Access Compliance Report

Public Rights-of-Way

(Curb Ramps)

Intersection ID: 5714	Main Street: JOHN_KIRK_DR	Cross Street: UNIVERSITY_CITY_BV	Location: S
ADA ID: 0D51A3A373BB	Ramp Type: Perp	Initial Pass/Fail: Fail	Overall Compliance: No
			Severity Score: 26.25

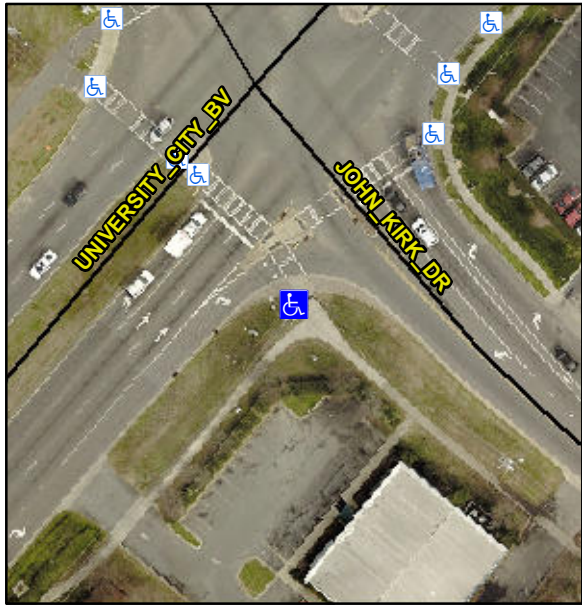
Codes/Mitigation Info/Possible Solution			Field Measurements/Component Compliance					
	Possible Solutions:		Compliance	Description	Data	Compliance	Description	Data
	Remove & Replace Entire Ramp.		N/A	Ramp Length (in)	108.0	No	Ramp Slope (%)	14.9
			Yes	Ramp Width (in)	63.0	No	Ramp XSlope (%)	3.6
			N/A	Flare Type LT	N/A	N/A	Flare Type RT	N/A
			N/A	Flare Slope LT (%)	N/A	N/A	Flare Slope RT (%)	N/A
			N/A	Flare Traversable LT?	N/A	N/A	Flare Traversable RT?	N/A
			N/A	Landing Length (in)	N/A	N/A	DWS Provided?	N/A
			N/A	Landing Width (in)	N/A	N/A	DWS Contrast?	N/A
			N/A	Landing Slope (%)	N/A	N/A	DWS Length (in)	N/A
			N/A	Landing X Slope (%)	N/A	N/A	DWS Full Width?	N/A
Surveyor Notes:		N/A	N/A	Landing Curb? (Y/N)	N/A	N/A	DWS Offset (in)	N/A
PROW/ADA:		Not Found, R304.2.2, R304.5.3	N/A	Shared Landing?	N/A			
			N/A	Gutter Ponding?	N/A	N/A	Gutter Slope (%)	N/A
			N/A	Gutter Lip Ht (in)	N/A	N/A	Gutter X Slope (%)	N/A
